Item Name: Heli-Utility-Basket™ - RH

DART SERVICE INSTRUCTION

TO AMEND INSTALLATION INSTRUCTIONS D205-541 REV. J AND
INSTRUCTIONS FOR CONTINUED AIRWORTHINESS ICA-D205-541 REV. 4
REF TCCA STC: SH96-120
REF FAA STC: SR00696NY
REF EASA STC: EASA.IM.R.S.01242

A	NEW ISSUE	DW	14.11.27
REV.	DESCRIPTION	BY	DATE
DESIGN	DW	DART AEROSPACE LTD HAWKESBURY, ONTARIO, CANADA	
DRAWN	DW		
CHECKED	AP	DRAWING NO. REV. A	
MFG. APPR.	N/A	DSI 9667 SHEET 1 OF 2	
APPROVED	<u>[Signature]</u>	TITLE SCALE	
DE APPR.	<u>[Signature]</u>	WASHER ADDITION NTS	
DATE	14.11.27	COPYRIGHT © 2014 BY DART AEROSPACE LTD THIS DOCUMENT IS PRIVATE AND CONFIDENTIAL AND IS SUPPLIED ON THE EXPRESS CONDITION THAT IT IS NOT TO BE USED FOR ANY PURPOSE OR COPIED OR COMMUNICATED TO ANY OTHER PERSON WITHOUT WRITTEN PERMISSION FROM DART AEROSPACE LTD.

FIGURE 1

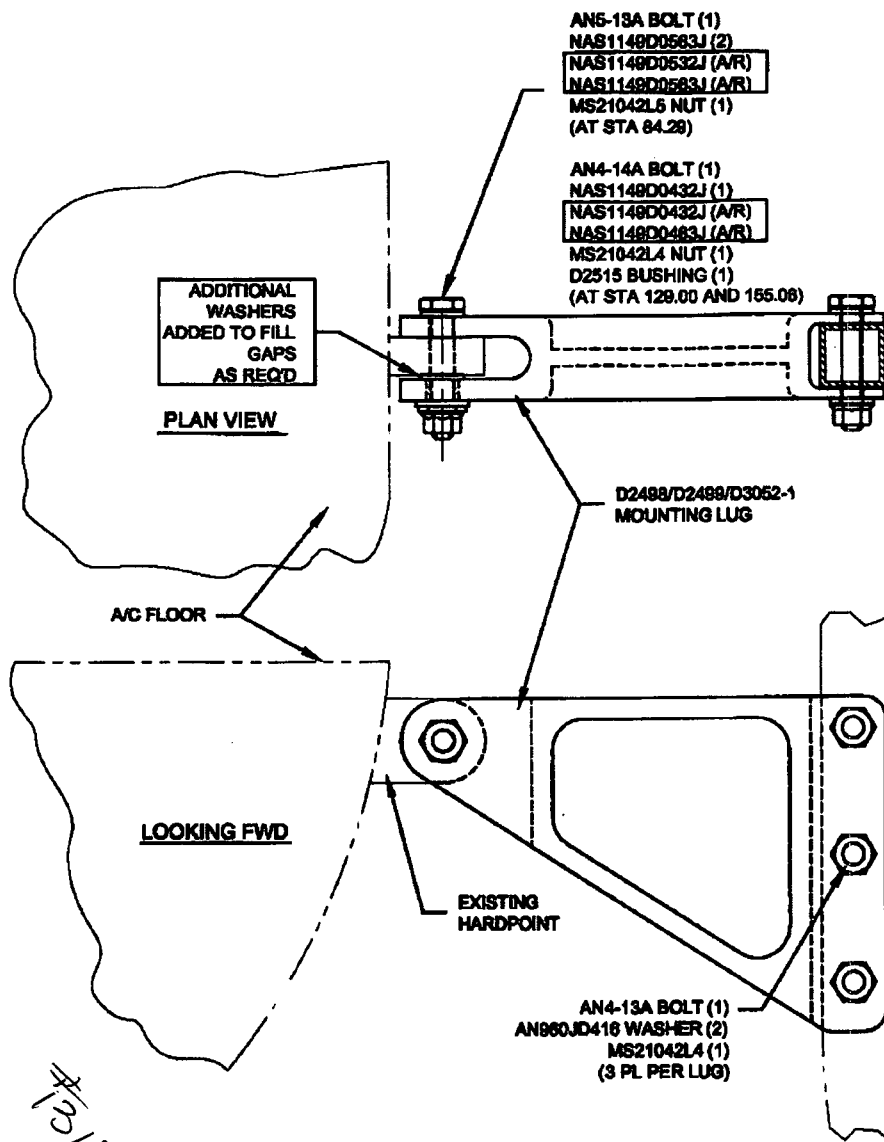
FOR CUSTOMERS/OPERATORS CONCERNED WITH GAPS AT STA's 84.29, 129.00 AND 155.06 WHILE INSTALLING D205-541-043/-044/-045/-046 BASKETS, IT IS ACCEPTABLE TO FILL THE GAPS WITH WASHERS TO REDUCE UNNECESSARY STRESS ON THE MOUNTING LUGS.

INSTALL THE D205-541-043/-044/-045/-046 BASKET KITS PER INSTALLATION INSTRUCTIONS D205-541 WITH ADDITIONAL WASHERS AS SHOWN IN FIGURE 1 OF THIS SERVICE INSTRUCTION.

4	4	4	4	NAS1149D0463J	WASHER
4	4	4	4	NAS1149D0432J	WASHER
2	2	2	2	NAS1149D0532J	WASHER
2	2	2	2	NAS1149D0563J	WASHER
